PLEASANT AVENUE PEAKS ISLAND
90-0-17

Alterations to Dwelling, Pleasant Ave, Peabody Island 9.0-0-17
 11/10/55

November 10, 1955

Examination of your application for a permit for making certain alterations to your dwelling at the above location discloses a number of framing questions which need to be worked out to meet Building Code requirements before a permit can be issued. These are as follows:-

Load on new Beam

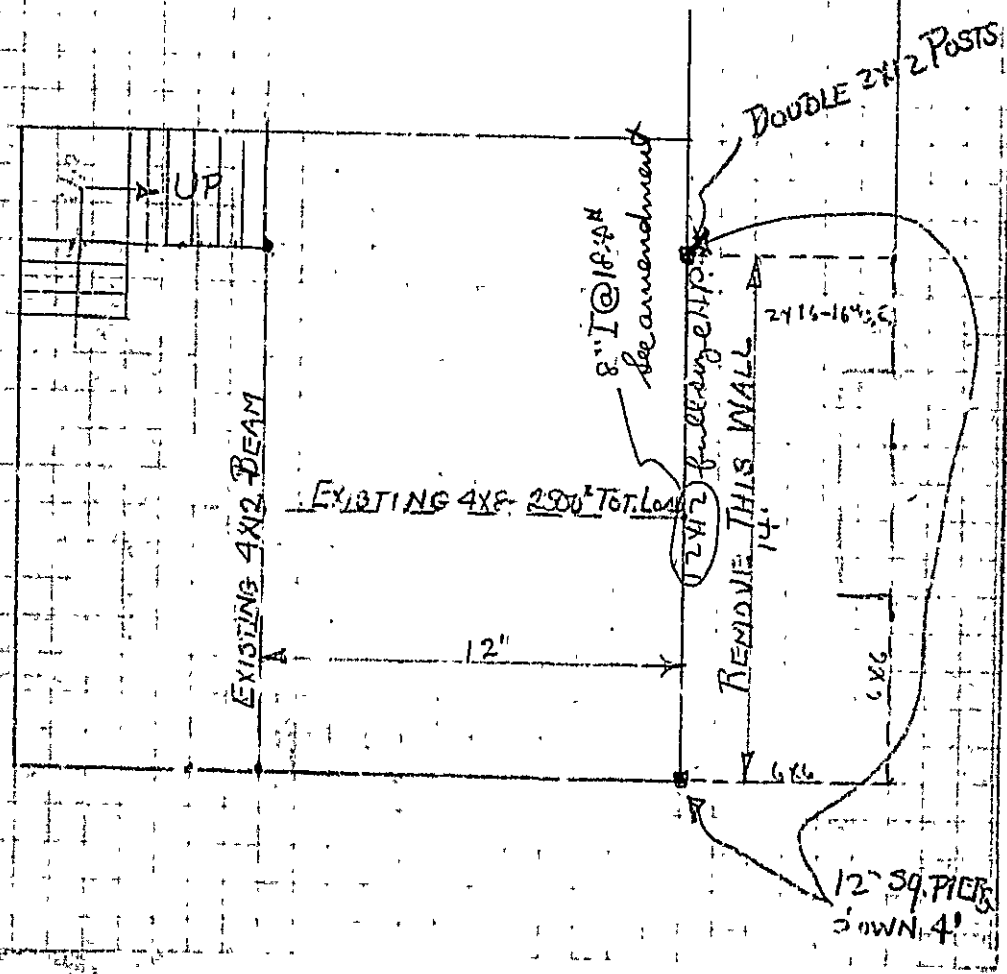
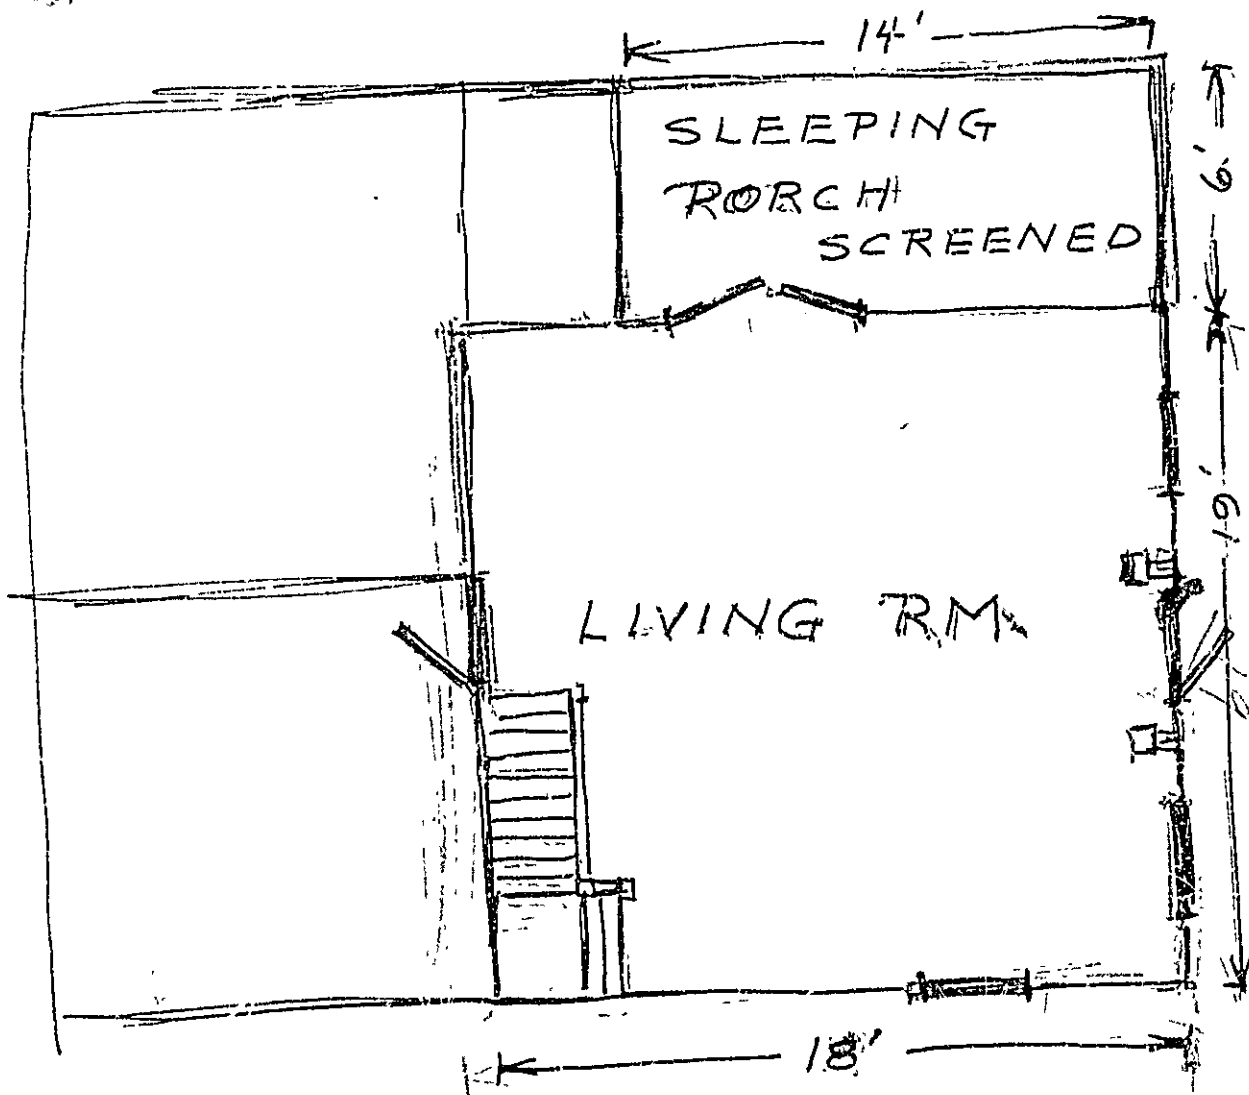
2nd Floor Load $6 \times 14 \times 4.0 = 3360^{\#}$
 Roof Load $12.5 \times 14 \times 30 = 5250^{\#}$
 Wall Load $3 \times 14 \times 10 = 1260^{\#}$
 Total floor load = $9870^{\#}$
 Conc. Load at center = $1250^{\#} = 2500^{\#}$
 Oppos. floor load = $12370^{\#}$

8" I @ 18" - 14' span = 13,500[#] - O.K.
 see amendment

To change 12x12 wooden beam to steel beam as per attached slip by Meguicr & Jones Co. and change posts to 4x6. 8 I @ 16'

PROPOSED CHANGE IN L.R. *Claudio Monteverdi*

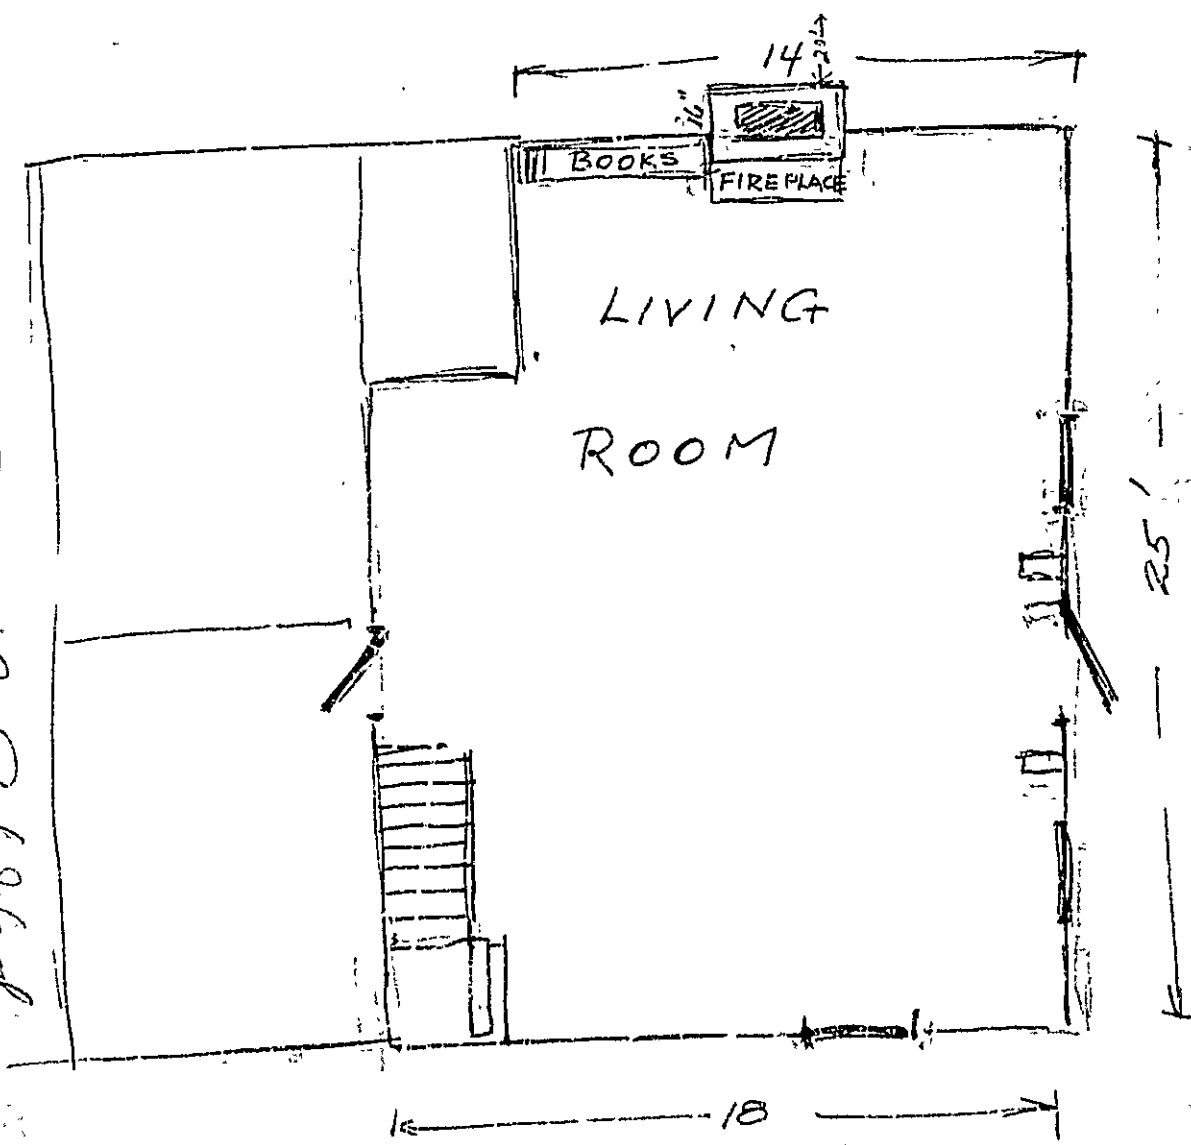
1. As near as we can determine from information you have furnished and data in our files covering previous alterations the 14-foot partition to be removed now carries part of second floor load and a large portion of the roof load on that side of the building as well as a concentrated load at the center of the span from one end of a beam installed several years ago when the original front wall of the building was removed. The total of these loads is such as to require for their support a beam having seven or eight times the carrying capacity of the 4x8 which you have indicated is to replace the wall to be removed. While it is possible to use a wooden beam for this purpose, the size needed is likely to be so large and ungainly as to make it impractical to use. If steel were used, a beam having much less depth and hence less interference with head room would undoubtedly take care of the situation. However, if steel is to be used, you will need to secure someone to determine the size needed and to give us a statement of design as to its adequacy.

2. Regardless of the type of beam used, information is needed as to what there is or will be for foundations to support the posts carrying the ends of this beam. What size posts will be used for this purpose?

3. What are the size, span and spacing of floor joists of the sleeping porch to be taken into the living room area? What is size of sills of this section of the building and how are they supported?

1. A 12x12 hard pine beam is to be installed where a portion of a bearing partition is to be removed. This beam is to be supported at each end on posts made up of two pieces of 2x12 securely spiked together. These posts are to be supported on concrete piers extending at least four feet below the surface of the ground.

2. The existing 4x8 beam under second floor now carried on partition to be removed, is to be supported on 12x12 beam by means of a timber hanger.

Alterations - Mrs. Sillia Montgomery - Cottage

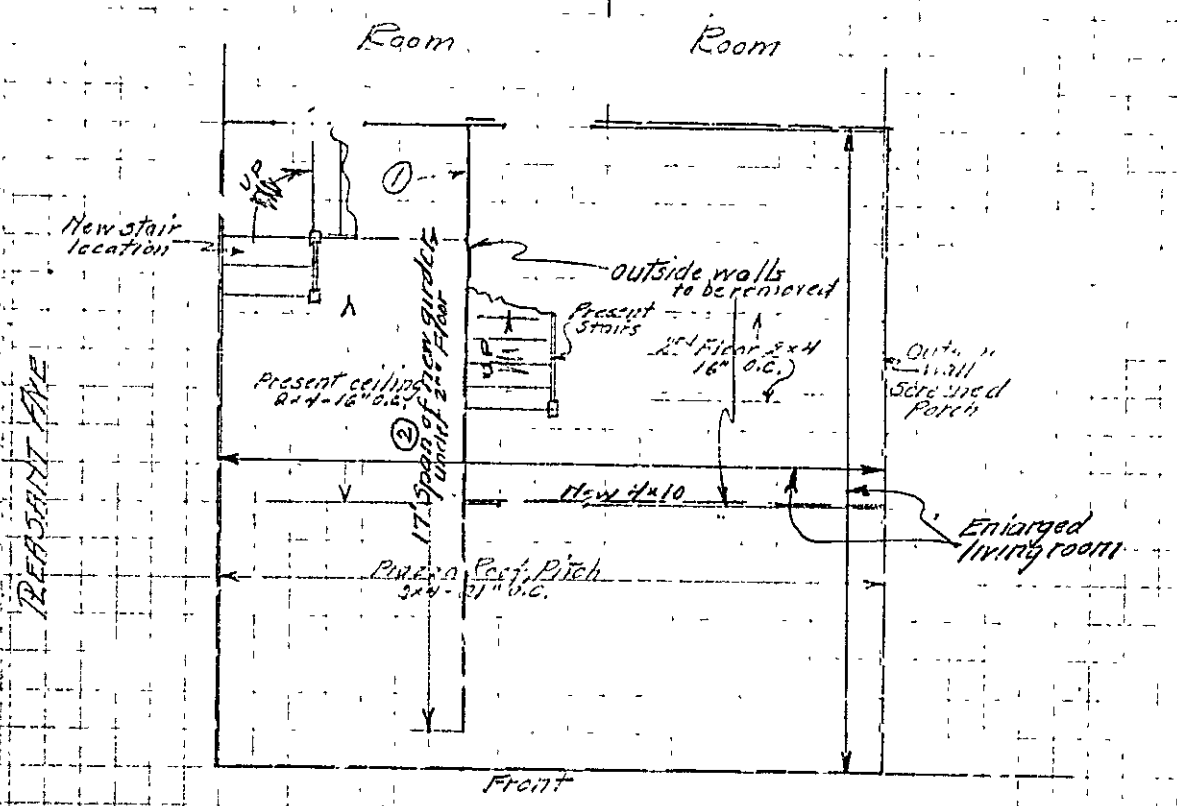
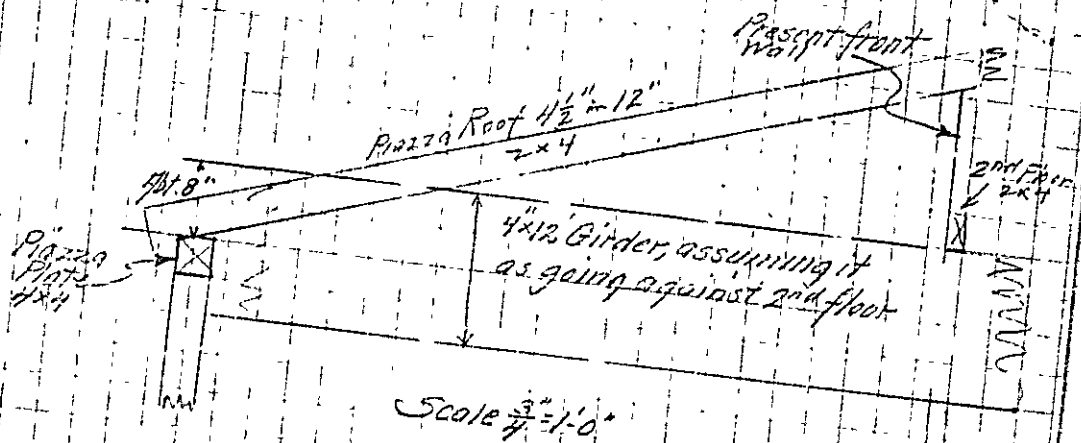
A. P. Fox, Inc. *Over*
 This plan is as a suggestion of what is to be done after my talk
 with Mr. Fox on this date.

① This area is an interesting space. Mrs. Montgomery would like to have the area as large as possible. The first and second floor areas would be identical in size. The major difference here is that if partition walls were 17' 4 1/2" wide 2nd floor would be 17' instead of 14'.

② Due to the fact that there is a difference of approx. 8" between the top of the piling or plate and underside of sheared floor joist, a post becomes necessary where the new 4x12 girder intersects the piling or roof. It was suggested that this 1/4" girder be centralized so that the posts at each end of this

girder be the same distance from their respective walls making a far better appearance than using the necessary post at one end only.

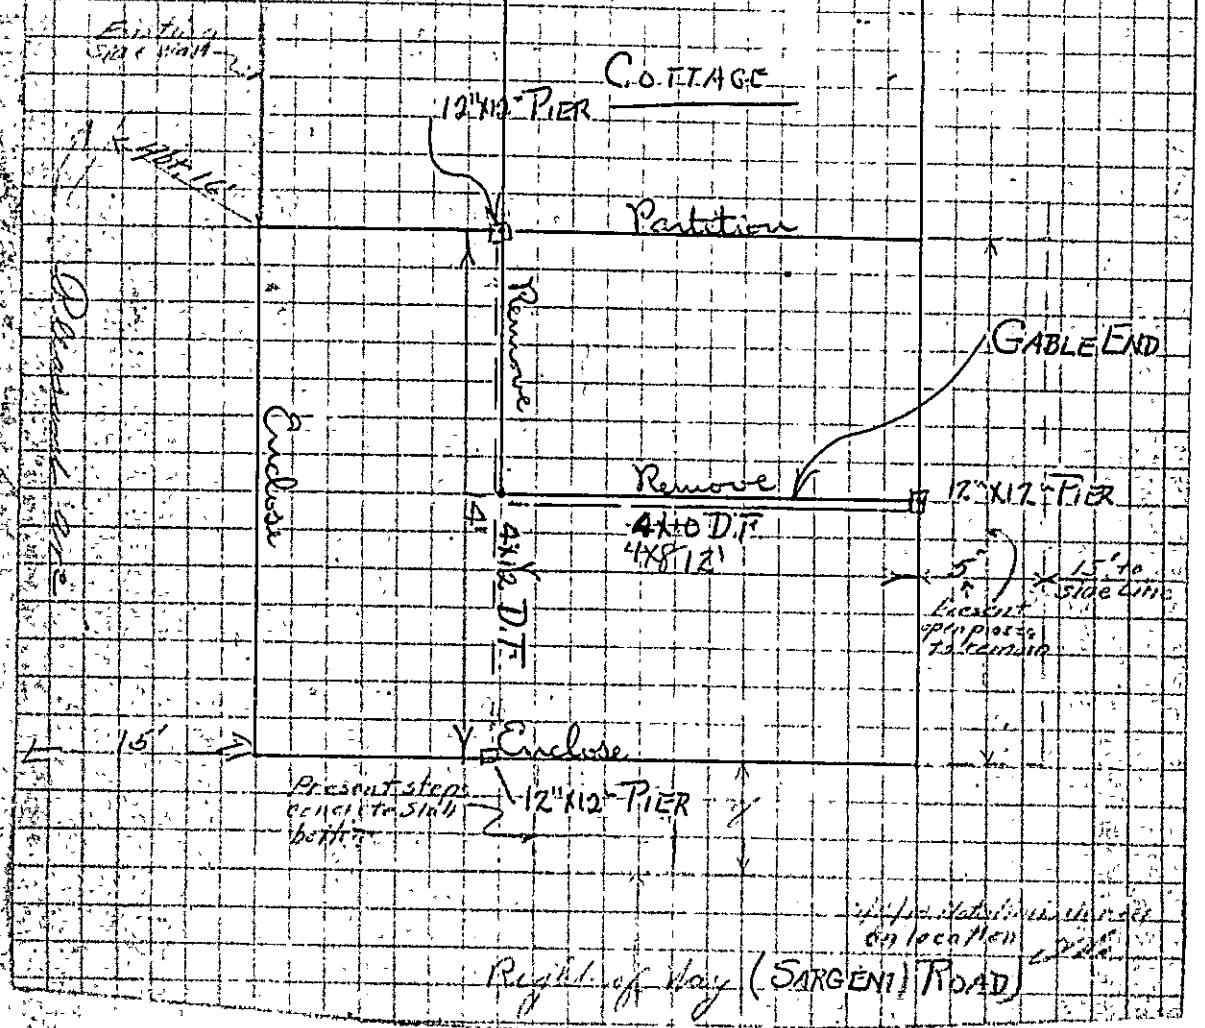
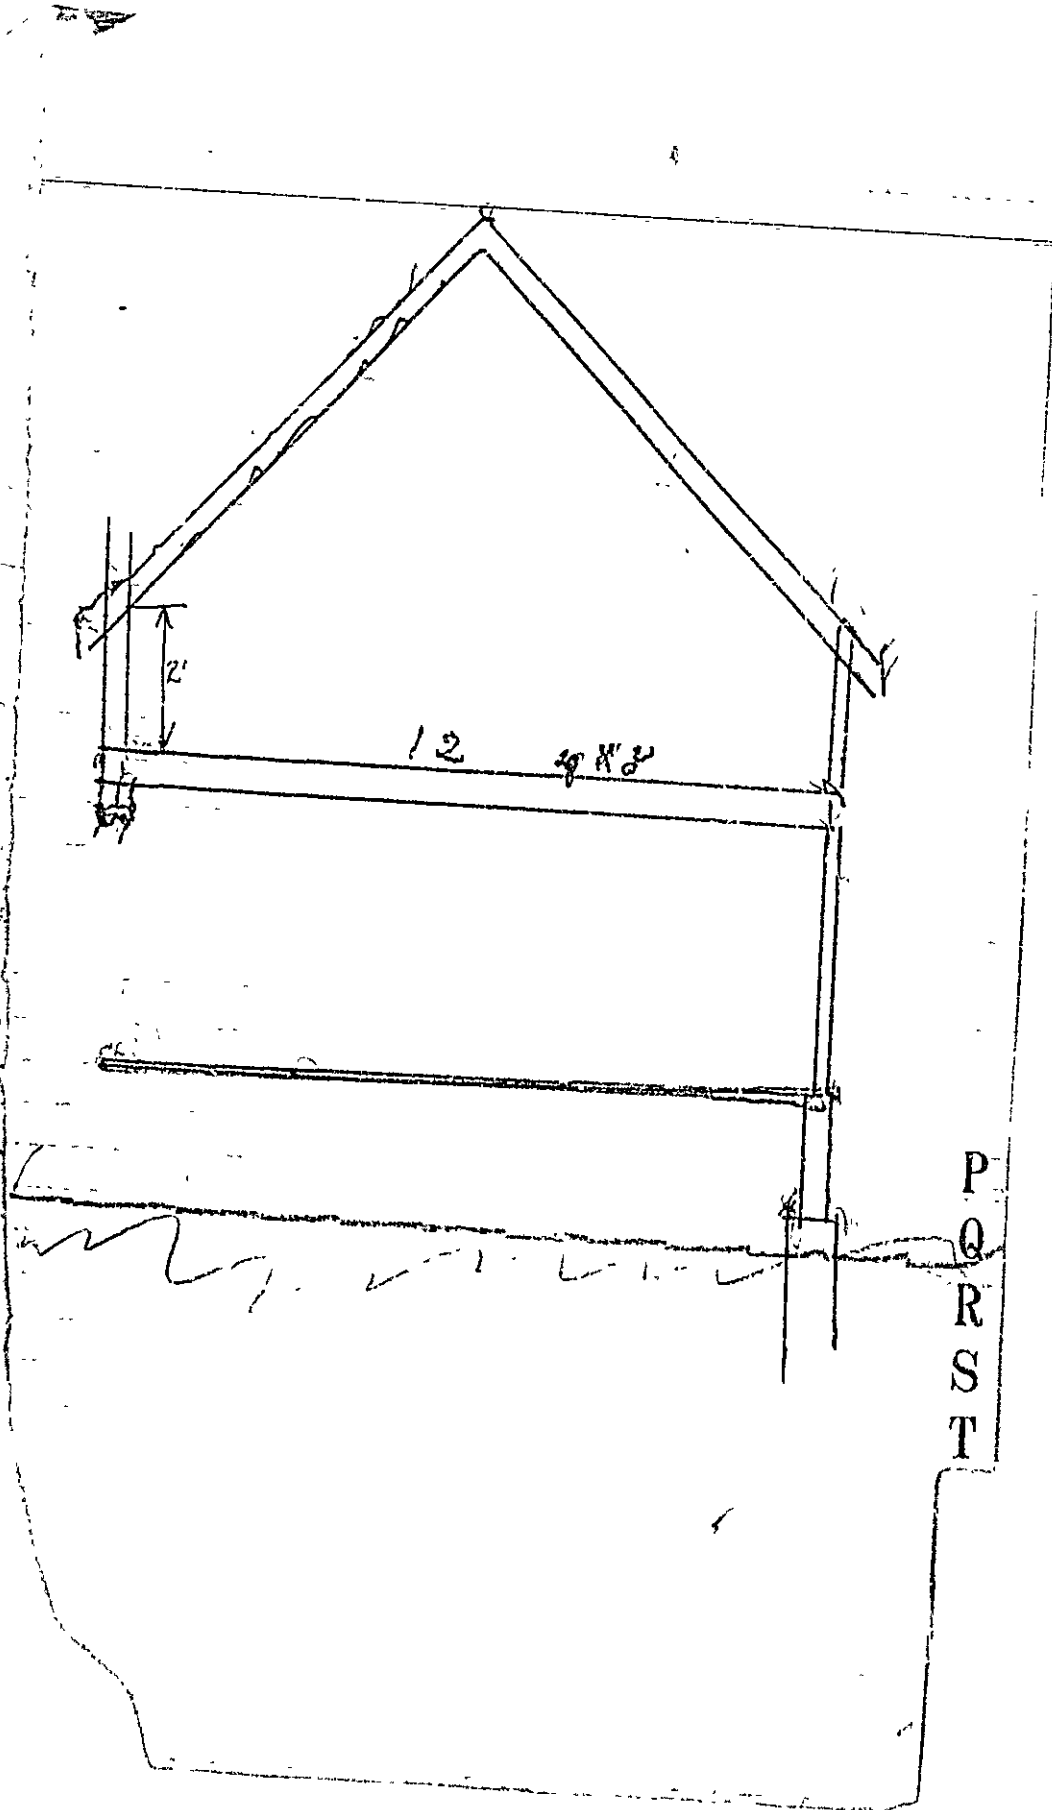
$$R_1 = \frac{(450 \times 7 \times 10) + (1250 \times 7)}{12} = 3354$$

$$M_{y-g} = (3354 \times 7) - (450 \times 7 \times 3.5) = 16,453$$

$$S = \frac{16,453 \times 12}{1500} = 916.2 \text{ req.}$$

S of 4x12 = 79.90 (dressed)
 S of 4x12 = 9.6 (full size)

5x12x10 = 600
 35x12x45 = 1890
 2490
 4x8 D.T. - 12 ft span = 2832

1. The 4x12 beam on a span of about 14 feet, which will
carry a part of the wall and roof load of the building as well
as one end of the 4x3 beam put in to replace the front wall of
the cottage when removed, will not figure cut unless it is of
Douglas Fir or Long Leaf Yellow Pine and full size, not dressed.
This permit is issued on the basis that this is what will be
provided.

2. A timber hanger or perhaps a piece of 2x3 spiked to
the side of the 4x12 is required for support of the 4x3 beam on
the 4x12.
